Well Name: PENNY 34/36 FED COM	Well Location: T22S / R26E / SEC 34 / NWSE / 32.348601 / -104.279482	County or Parish/State: EDDY / NM
Well Number: 716H	Type of Well: CONVENTIONAL GAS WELL	Allottee or Tribe Name:
Lease Number: NMNM96203	Unit or CA Name:	Unit or CA Number:
US Well Number: 3001554346	Well Status: Drilling Well	Operator: MEWBOURNE OIL COMPANY

Notice of Intent

Type of Submission: Notice of Intent	Type of Action: APD Change
Date Sundry Submitted: 12/15/2023	Time Sundry Submitted: 07:58
Date proposed operation will begin: 12/20/2023

Procedure Description: Mewbourne Oil Company requests permission to: Change the name of the GAMBINO FEDERAL COM 2H (API # 30-015-54346) to the PENNY 34/36 FED COM 716H Perform offline cementing and BOPE break testing as detailed in the attached documents See attached C102 and variance documents

Figure 1. BOP diagram

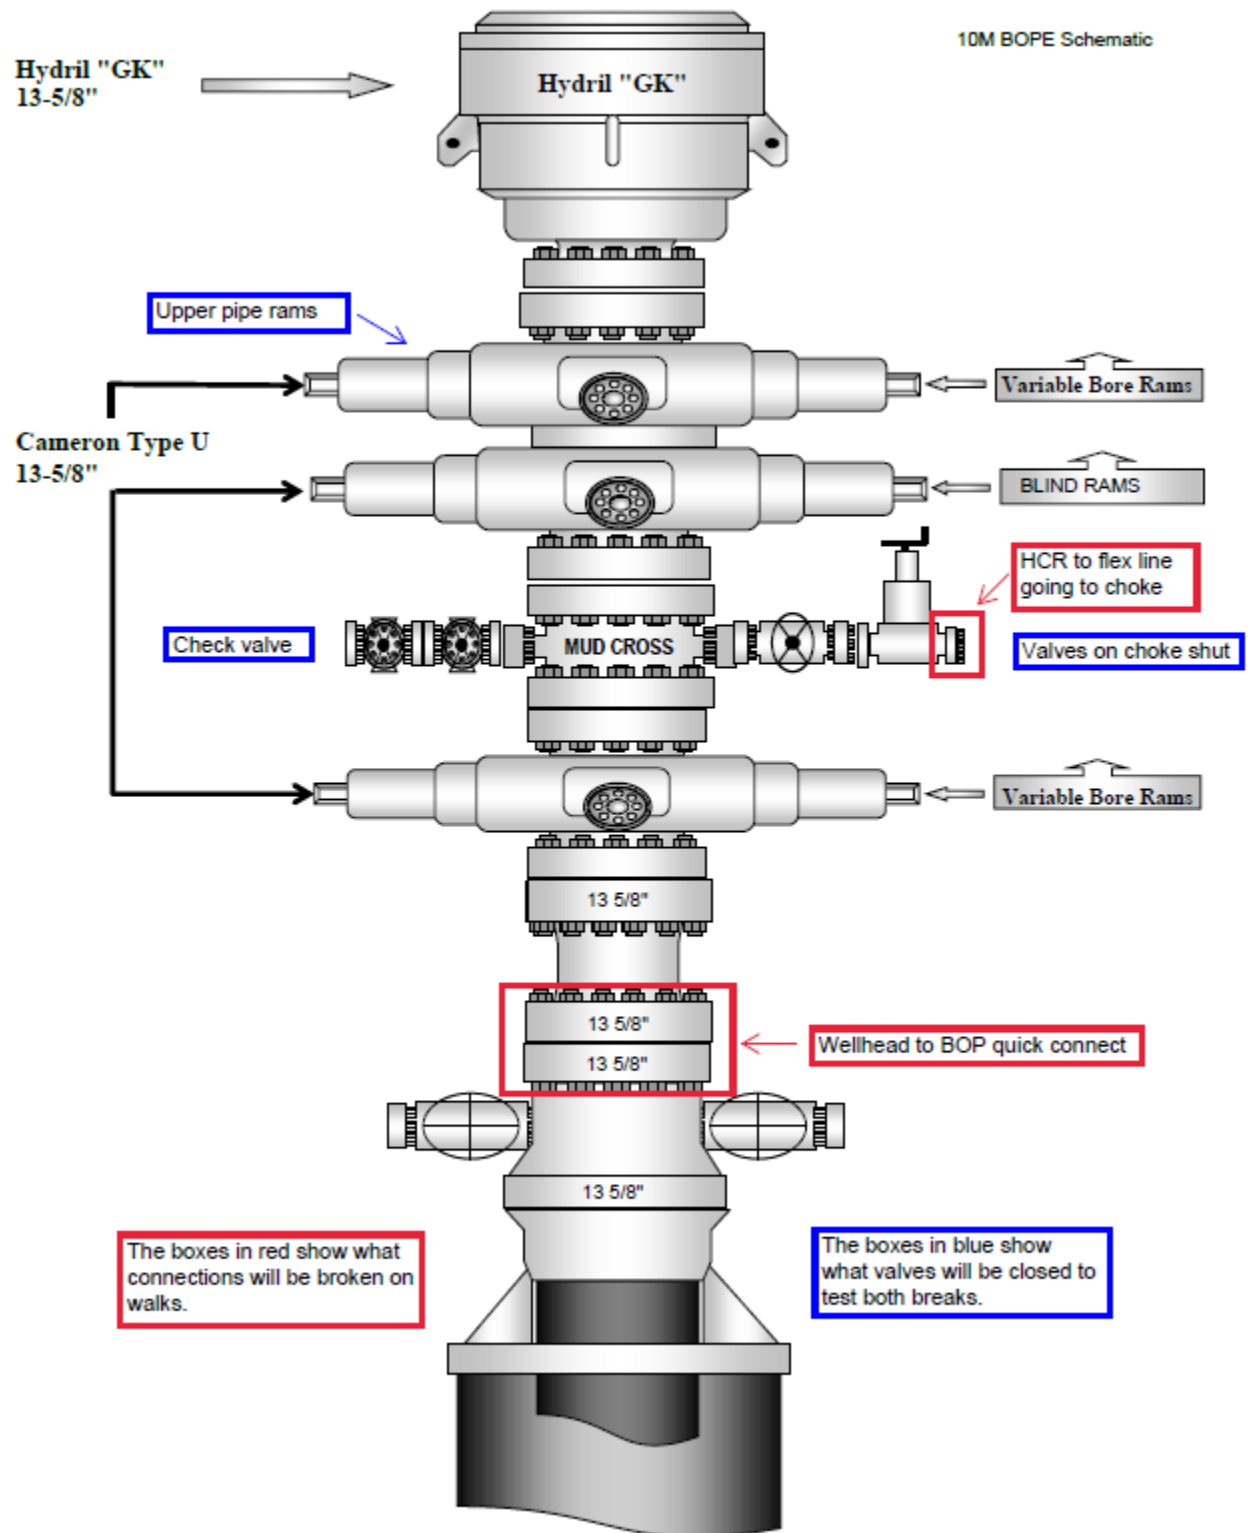
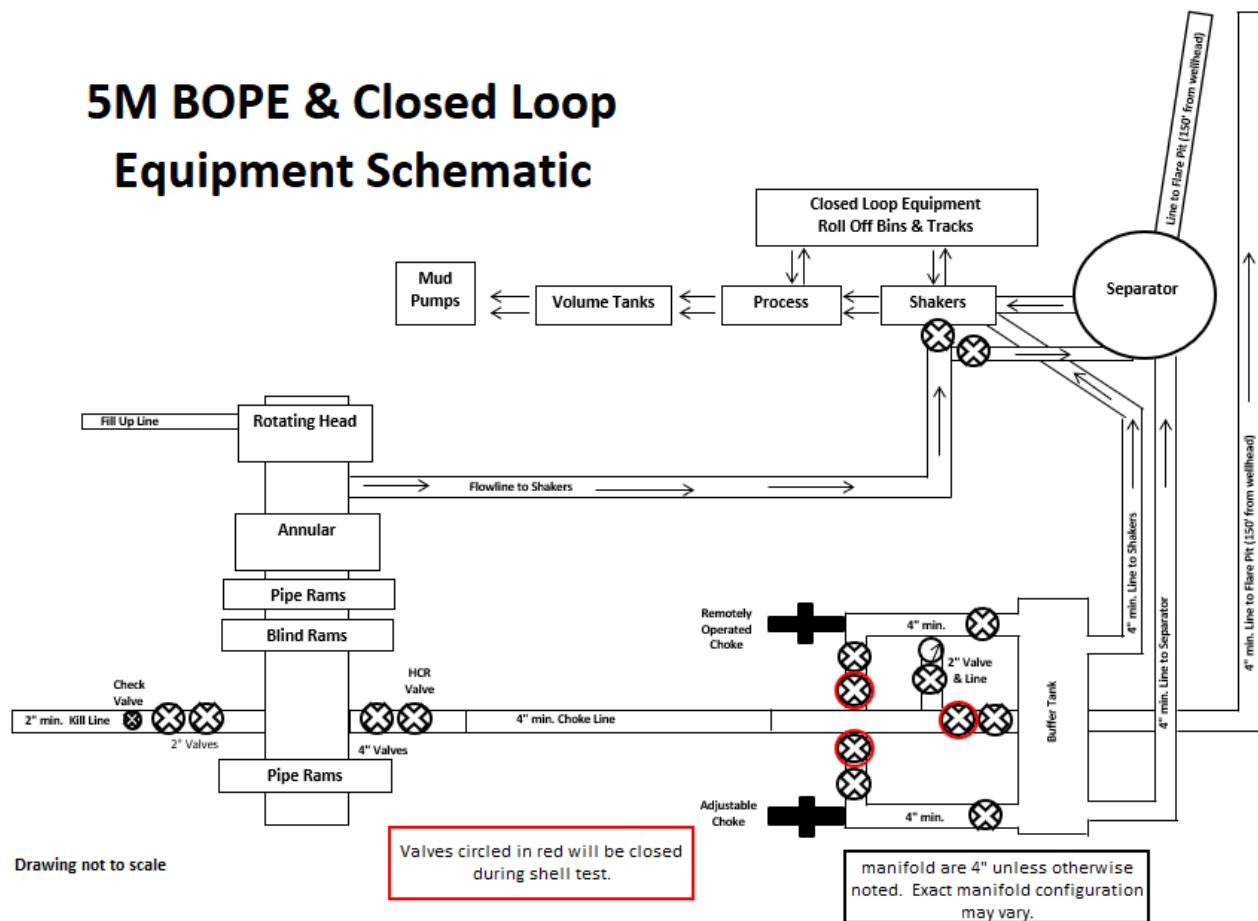
2. After the well section is secured and the well is confirmed to be static, the BOP will be disconnected from the wellhead and walked with the rig to another well on the pad. Two breaks on the BOPE will be made (Fig. 1).

9. A test will then be conducted against the upper pipe rams and choke, testing both breaks (Fig. 1 & 2).
10. The test will be held at 250 psi low and to the high value submitted in the APD, not to exceed 5000 psi.

Figure 5. Cactus 5M wellhead with BOP quick connect

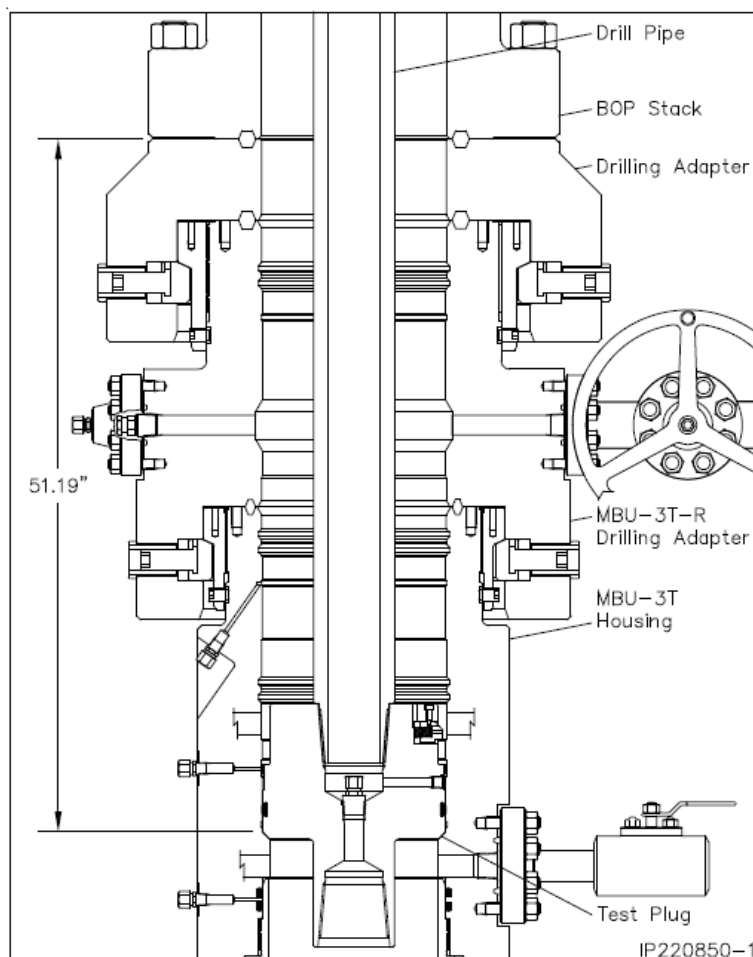
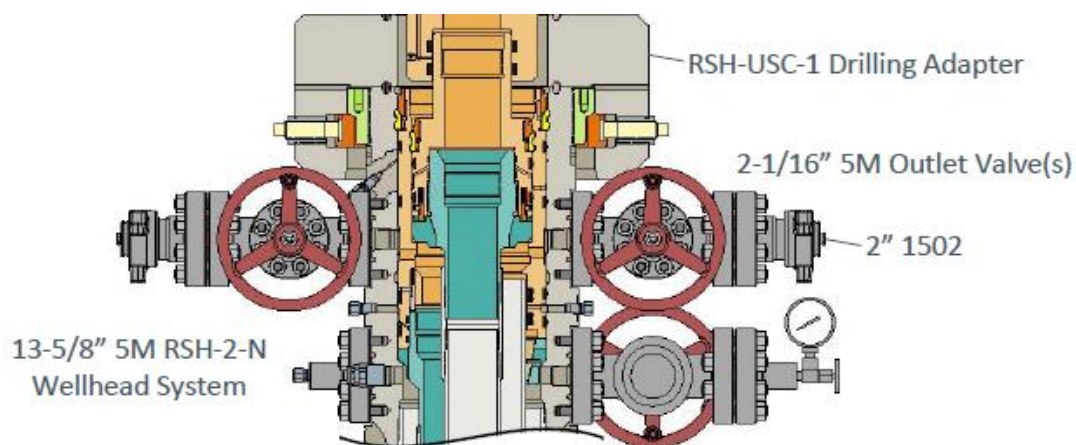
- Connection between the flex line and the HCR valve
 - Connection between the wellhead and the BOP quick connect (Fig. 5 & 6).
3. A capping flange will be installed after cementing per wellhead vendor procedure & casing pressure will be monitored via wellhead valve.
